State of Ohio Environmental Protection Agency

August 4, 2008

**Re: Construction Storm Water Inspection at N K Parts**

Figure 1 Barren area of site

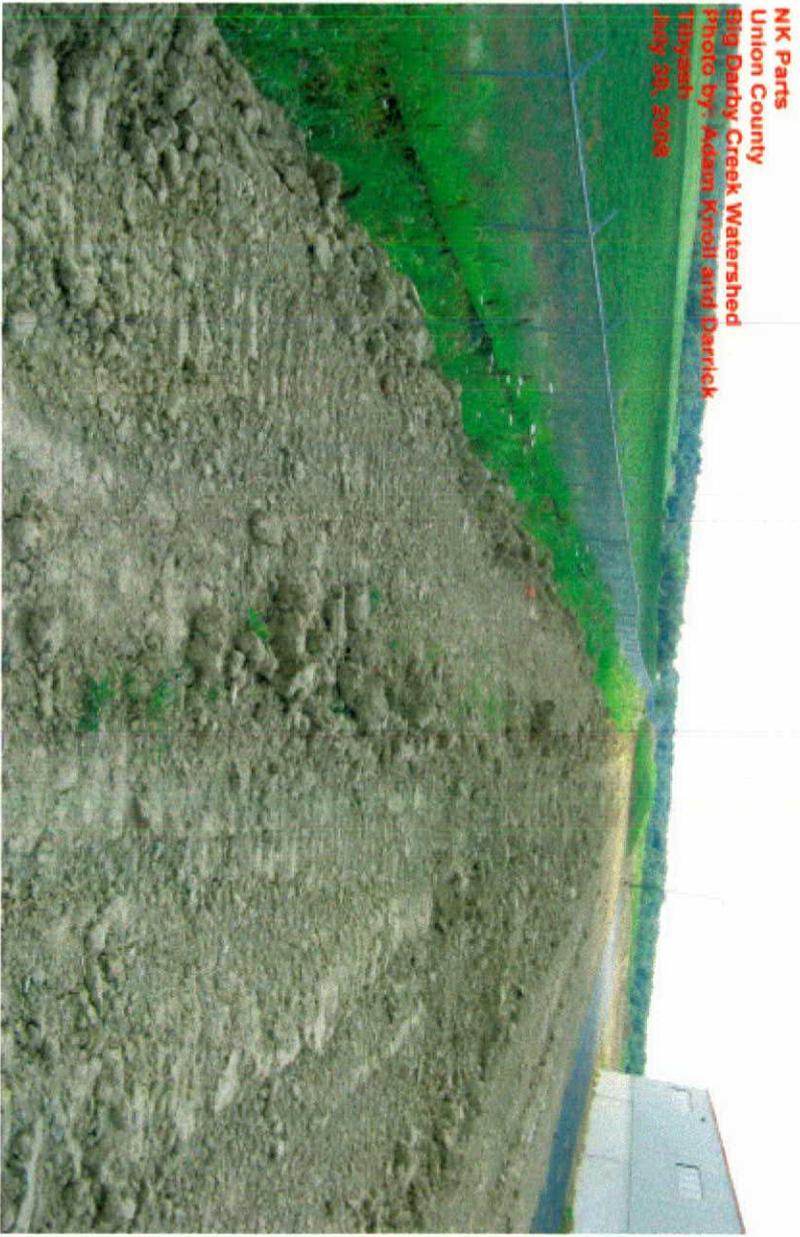
- Be aware the General Permit states that all barren areas which remain idle in excess of 21 days must be protected from erosion within seven days of the last earth disturbing activities. In addition, erosion protection must be implemented for all areas of final grade within seven days (See Photo, Figure 1).
- Perimeter sediment controls appeared to be functioning in accordance with the General Storm Water Permit at the time of inspection. The general permit states that all sediment controls will be inspected and maintained every seven days or within 24 hours of a precipitation event equal to or greater than 0.5 inches. A log of inspection(s) must be maintained on site for the agency to review.
- The sediment impoundment associated with this site appeared to be functioning in accordance with the General Storm Water Permit at the time of inspection (See Photo, Figure 2).
